Classification:
EC19-021a

Reference:
ITB19-026a

2019 QX50; FUEL ODOR INSIDE VEHICLE

Figure 3

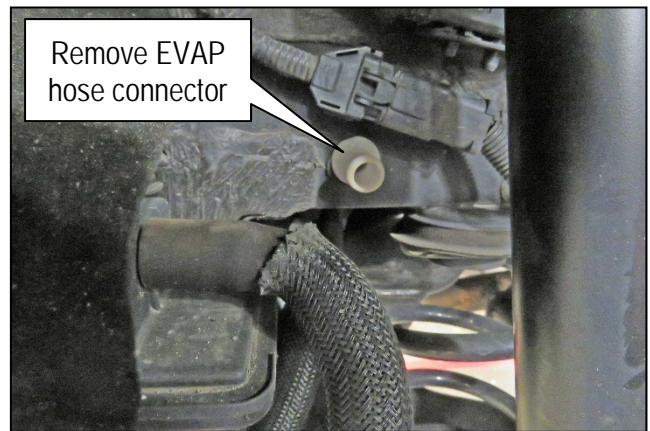
- Using a suitable tool, remove the white plastic EVAP hose connector from the frame and discard (Figure 3).

Figure 4

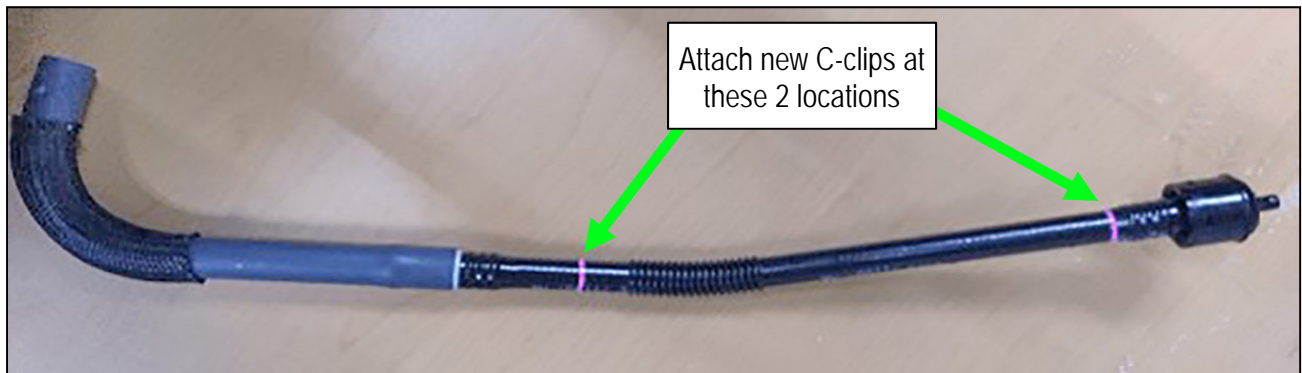
- Attach two (2) new C-clips to the new EVAP canister filter vent hose at the locations marked in pink in Figure 4.
 - The new EVAP canister filter vent hose and C-clips are listed in **PARTS INFORMATION** on the last page of this bulletin.
